Project	<b>IEEE 802.16 Broadband Wireless Access Working Group</b> < <a href="http://ieee802.org/16">http://ieee802.org/16</a> >	
Title	<b>Proposal to Amend Section 8.3.5.16 of TG3&amp;4 Draft Document</b>	
Date Submitted	<b>2001-07-06</b>	
Source(s)	<p>Russell McKown, Wayne Music Raze Technologies, Inc. 2540 E. Plano Pkwy, Suite 1282 Plano, Tx, 75074-7460</p> <p>Brian Eidson Conexant Systems, Inc. 9868 Scranton Rd San Diego, CA 92121</p>	<p>Voice: (972) 516-1282 Fax: (972) 578-9081 <a href="mailto:rmckown@razetechnologies.com">mailto:rmckown@razetechnologies.com</a></p> <p>Voice: (858) 713-4720 Fax: (858) 713-3555 <a href="mailto:brian.eidson@conexant.com">mailto:brian.eidson@conexant.com</a></p>
Re:	TG3&4 Draft document	
Abstract	This document is an amendment to Brian Eidson 2001-07-07 submission for a new section 8.3.5.16 to replace the old one in the 802.16ab draft document. Section 8.3.5.16 describes some example burst configurations and affiliated processing techniques within the Single Carrier mode.

# Proposal to Amend Section 8.3.5.16 of TG3&4 Draft Document

## 8.3.5.16 Examples of Burst for 256-point FFTs

Figure 3a: Burst with 256 pt Overlapping FFTs: One-sided Overlap and Save Option

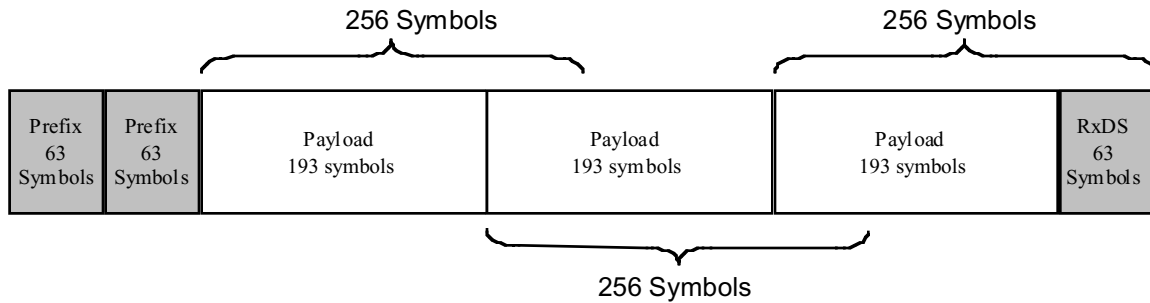
**ATTACHMENT TO BE INSERTED**

Figure 3a illustrates another example of how overlapping FFTs may be used in an overlap-save processing scheme. Note that only the first 63 symbols of an FFT are eliminated, post equalization. The payload length restriction in the illustrated case is that the payload is 193 J symbols long, where  $J = 0, 1, 2, \dots$ . Here the transmit efficiency is  $E = (193 J) / (193 J + 63 N + 63)$ , where J is the number of 193 symbol payload sub-blocks transmitted, and N is the number of Unique Words (1 or more) composing the (initial) acquisition sequence. Note that this reduced overlap provides for more efficient use of the TDD bandwidth for those channels and processing schemes which support the reduced overlap. Note again that by increasing the overlap factor, the payload granularity may be decreased, so that payloads are M J symbols long, where  $M < 193$ . For this more general case,  $E = M J / (M + 63 N + 63)$ .
